Request for Additional Information No. 111 (1446, 1471, 1508), Revision 0

11/03/2008

U. S. EPR Standard Design Certification

SRP Section: 06.02.02 - Containment Heat Removal Systems

Figure 06.02.02-8-2—TSP Basket Location With Respect to the ECCS Sump Blockage Design Mitigation Features

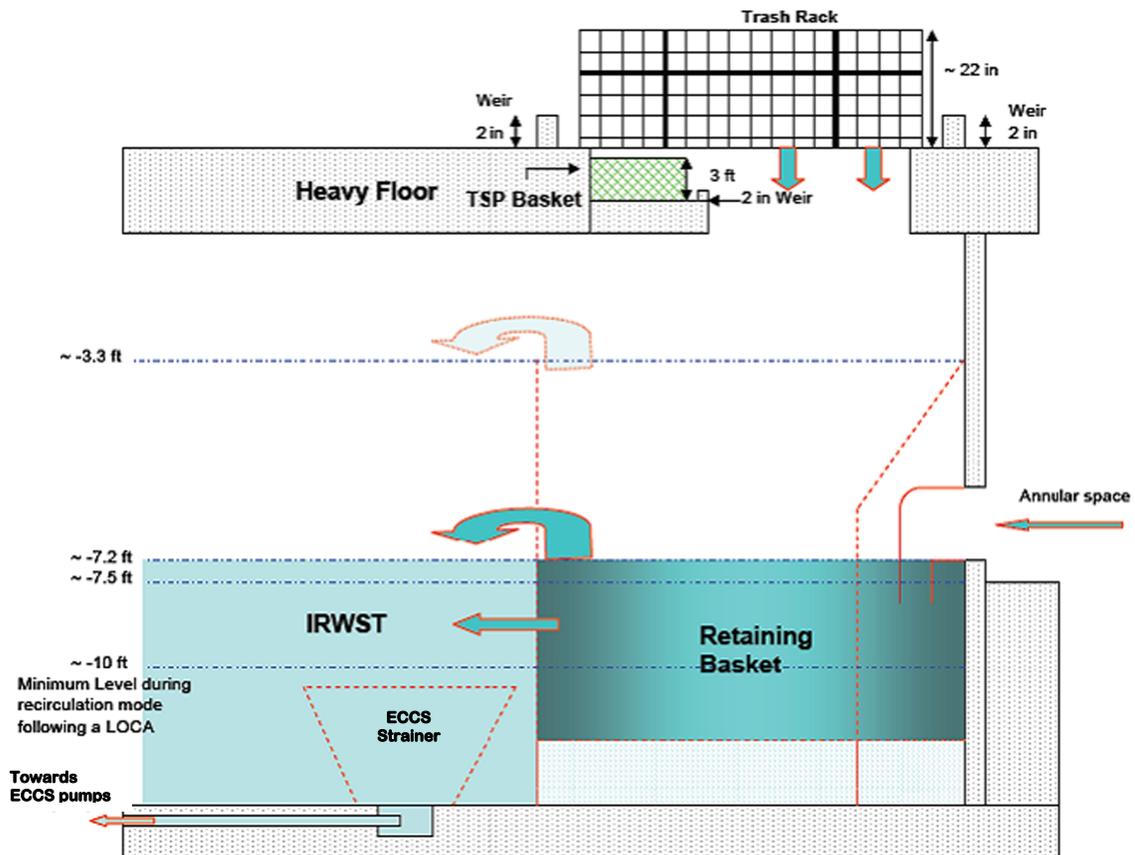
3. FSAR Section 6.3.2.2.2 discusses buffering solution. Please clarify how chemical buffer (TSP) is arranged within the boundary perimeter of the weir/trash rack.

9. Per ANP-10293, each of the retaining baskets has approximately the same screen surface area for screening out debris. Please provide a sketch or drawings that outline how these baskets and subcompartments, as applicable, are arranged and highlight credited surface areas used to perform their design functions. What is the minimum basket volume and surface area needed to support flow from the heavy floor? What is the minimum basket volume and surface area needed to support flow into the compartment dedicated to annular flow? Provide the basis for these volumes and surface areas.

1. The response will be provided by March 15, 2009.
2. The response will be provided by March 15, 2009.
3. The tri-sodium phosphate (TSP) baskets are located in the containment heavy floor opening below the IRWST trash racks. Figure 06.02.02-8-2 shows the location of the TSP basket for each of the four heavy floor openings and its relation to the ECCS sump blockage mitigation design features.

8. The total combined volume of the two single compartment retaining baskets is 3000 ft³.
9. See Figure 06.02.02-8-2 in item 3 above. The minimum requirements for the retaining baskets needed to support the heavy floor are 1589 ft³ and 721 ft². The minimum requirements for the smaller compartment of the double compartment retaining basket needed to support the annular space are 530 ft³ and 269 ft². These sizes are based on collecting all debris in one retaining basket.
